PETITION NO: Z-24

PROPOSED USE: Single-Family
Subdivision

APPLICANT: Pulte Home Corporation

ZONING COMMENTS:

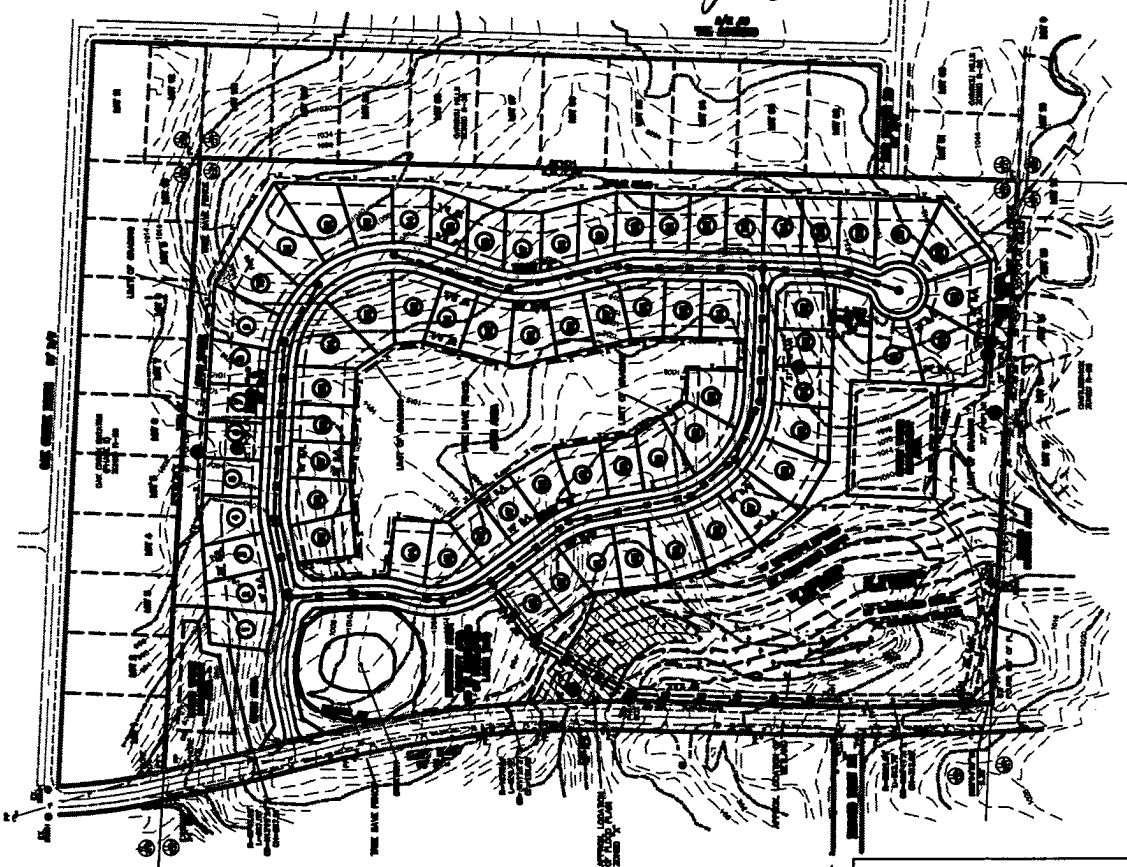
1. Both detention ponds must be located on separate parcels with adequate direct access from the public right-of-way. The northern most detention pond is located directly adjacent to a neighboring existing residential subdivision. Adequate landscaping must be provided to screen this pond from the existing residences.

4. Stormwater management areas need to be identified as structural or non-structural. If stormwater management area is structural then it can not be calculated within open space and be subtracted from total open space area.

5. Wetlands can only account for 75% of required open space. The total wetland area is approximately 8% of required open space so entire wetland area can be calculated within open space. Because Floodplain is Zone X or 500 yr floodplain there is no need to include it as part of the 75% requirement.
